Work Order ID 111378

Item ID: D212-664-101TRN Accept *N900040100* Setup Start *NS1*
 Revision ID: Stop *NS2*
 Item Name: Crosstube Turning Detail
 Start Date: 1/14/14 Start Qty: 1.00 *1* Cust Item ID:
 Required Date: 1/28/14 Req'd Qty: 1.00 *1* Customer:
 Reference:

DART AEROSPACE LTD		Work Order:	111378
Description: Crosstube Assembly (205/212/412 High Fwd)		Part Number:	D212-664-141
Inspection Dwg: D212-664-141 Rev: D		Page 1 of 2

DRAWING NO. D212-664-141	TITLE XTUBE ASSY (205/212/412 HI FWD)	REV. D	DART AEROSPACE LTD ENGINEERING ORDER		D.E.O. NO. D212-664-141-D-1	SHEET NO. SHEET 1 OF 2	SCALE NTS
DRAWN	CHECKED	MP	MFG. APPR.	APPROVED	MP	DE APPR.	
DATE 11.04.07	DATE 11.04.11		DATE 11.04.12	DATE 11/04/12		DATE 11.04.12

**D212-664-141/-141B
ASSEMBLY DETAIL**

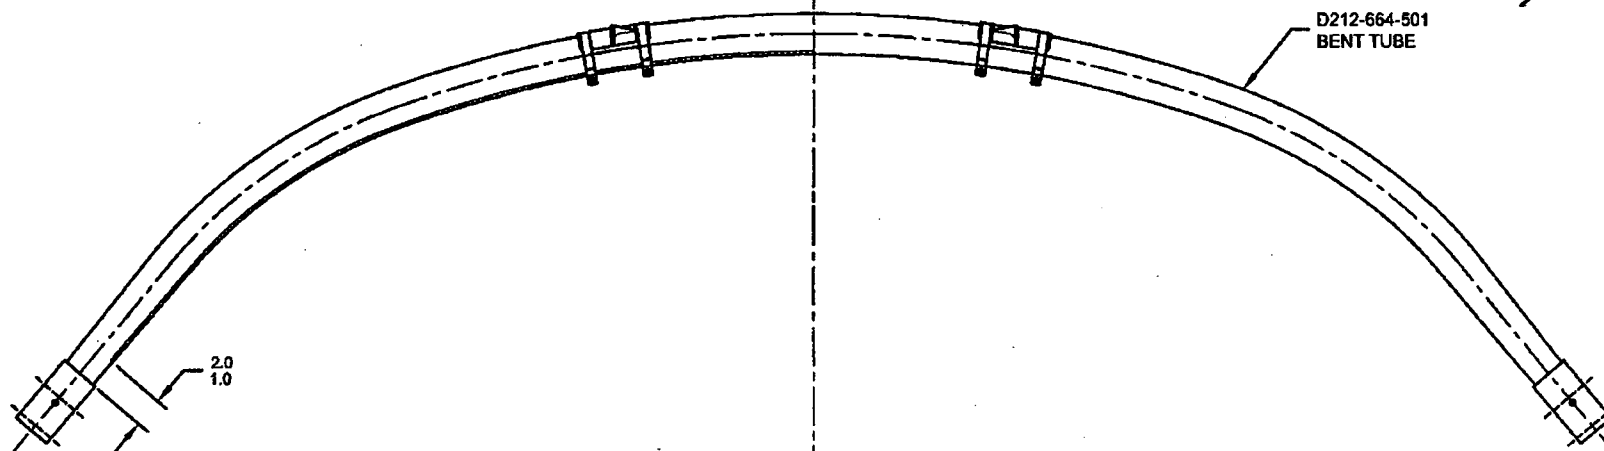
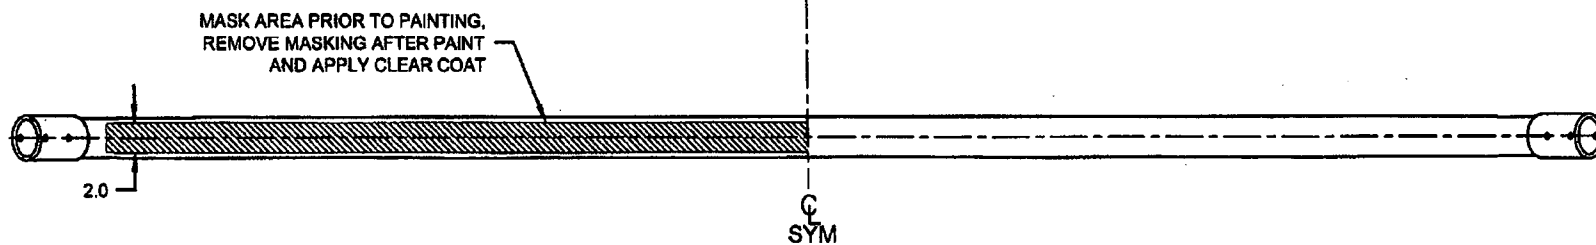
PURPOSE:

ADD AN INSPECTION WINDOW TO UNDERSIDE OF CROSSTUBE.

CHANGE:

NOTES 2 OF SHEET 1 IS AMENDED AS FOLLOWS:

- 2) FINISH: CHEMICAL CONVERSION COAT PER DART QSI 005 4.1
PRIME INSIDE AND OUTSIDE PER DART QSI 005 4.2
MASK UNDERSIDE OF CROSSTUBE AS SHOWN (HATCHED AREA) AND
PAINT OUTSIDE PER DART QSI 005 4.2
REMOVE MASKING AND APPLY CLEAR COAT
